SEPTIC SYSTEM ~~REVIEW~~ *AS BUILT*

SEPTIC PERMIT # 3-58-18
 Owner: Donald & Jill McGraw
 Site : 1137 Cross Creek Road
 Installer: Westin Mechanical

Permit to Construct

Sheridan County Small Wastewater Application Form

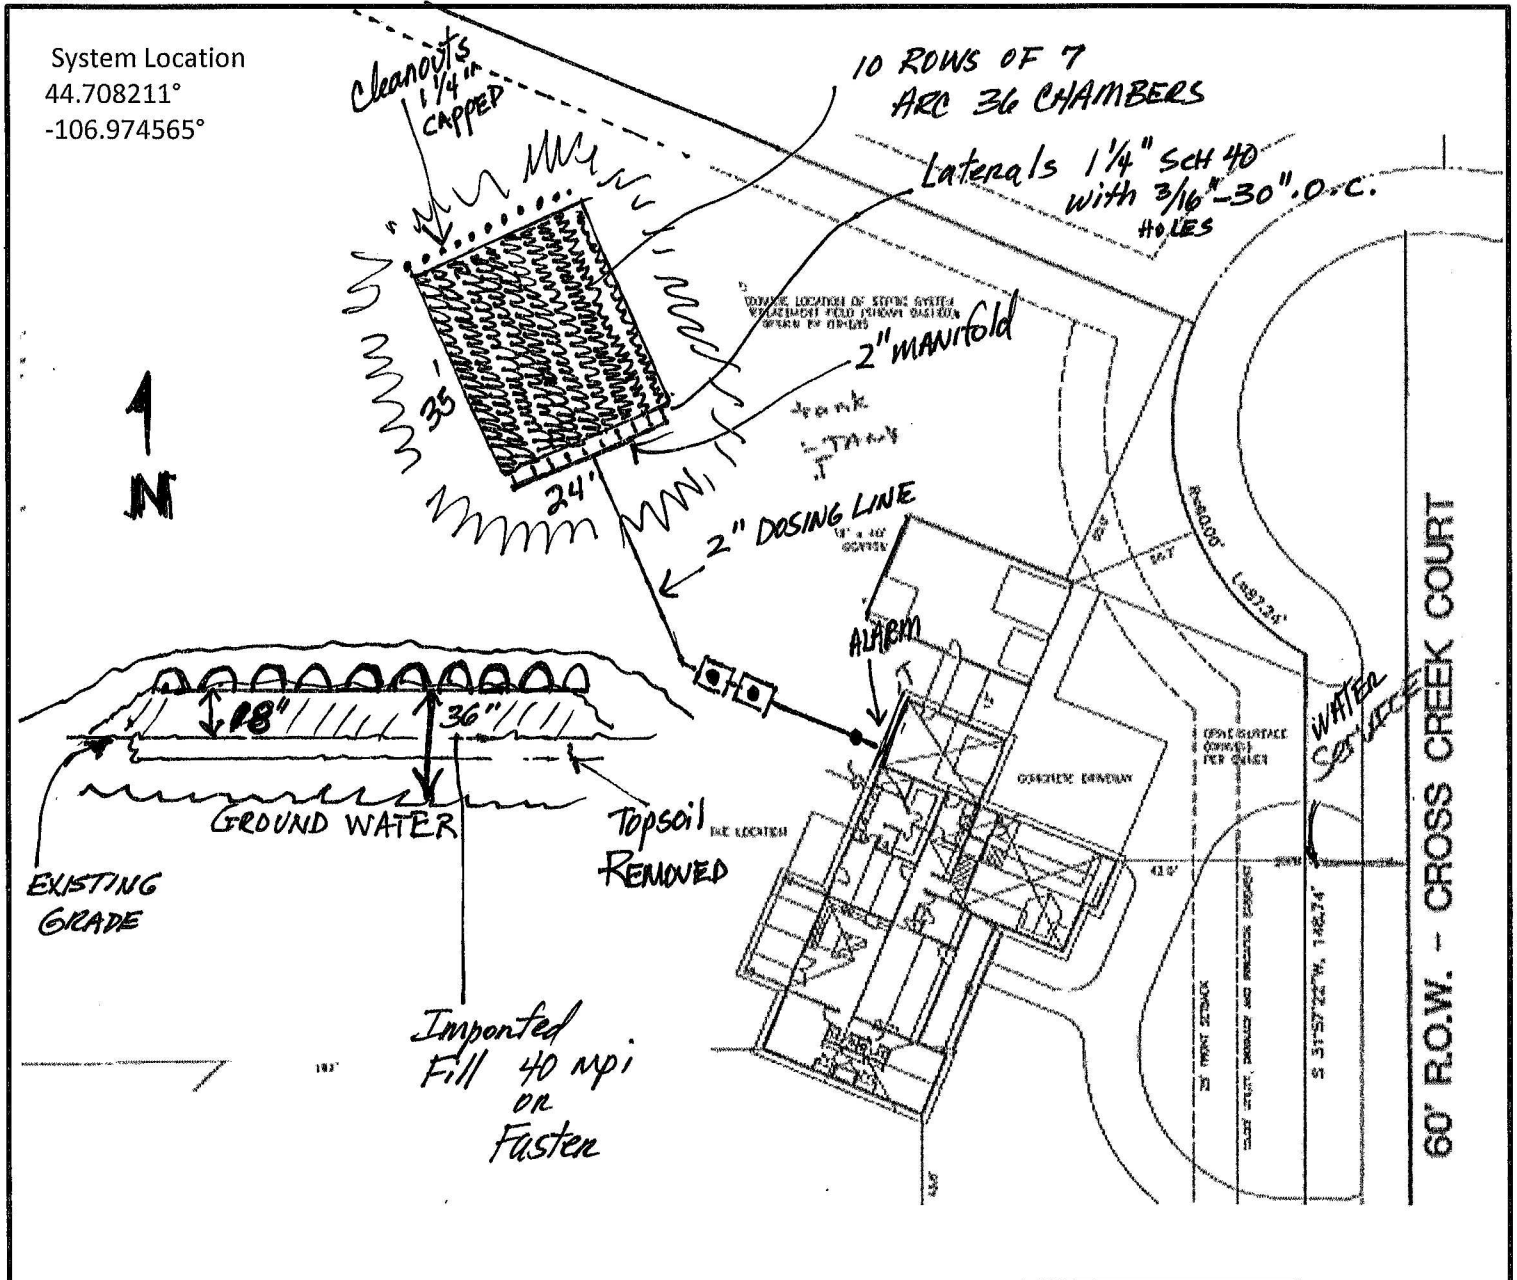
Single Family Dwelling 4 bedrooms = 470 gpd 470 gpd flow rate
 ground water test pit done 9/26/2018 excavated 5 ft. water indicators at 1.66 feet
 Bottom of field 1.33 ft. above existing grade

Septic Tank: MP1250 gal. Concrete septic tank (1000 gal. CDT dosing tank with Model Liberty 370/380 Pump set at 41 GPM)

Perc Rate 40 mpi Loading Rate = 0.35
 470 divided by 0.35 equals 1342.8571 sq.ft. absorption
 70 x 21.3 equals 1491 sq.ft. absorption

Chamber Bed System	FULL DOSING						
70	x	21.13	equals	1479.1	sq.ft. absorption	APPROVED

Final Inspection – Sheridan County

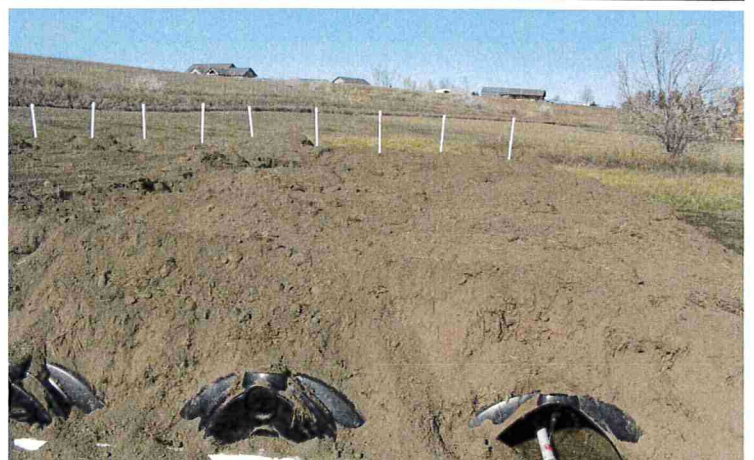
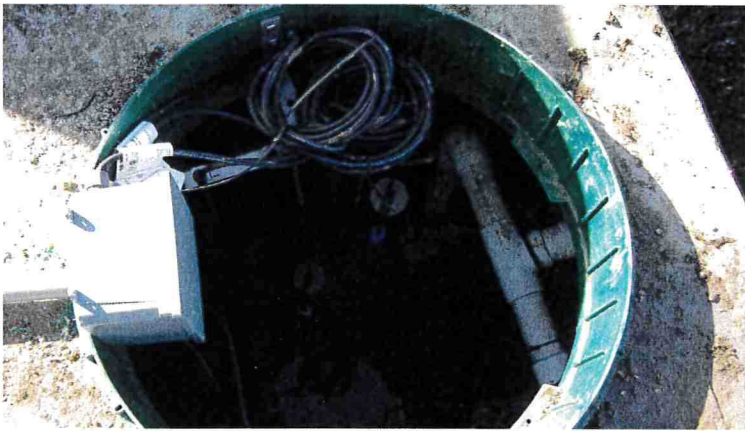
Inspected by WS 11/13/18
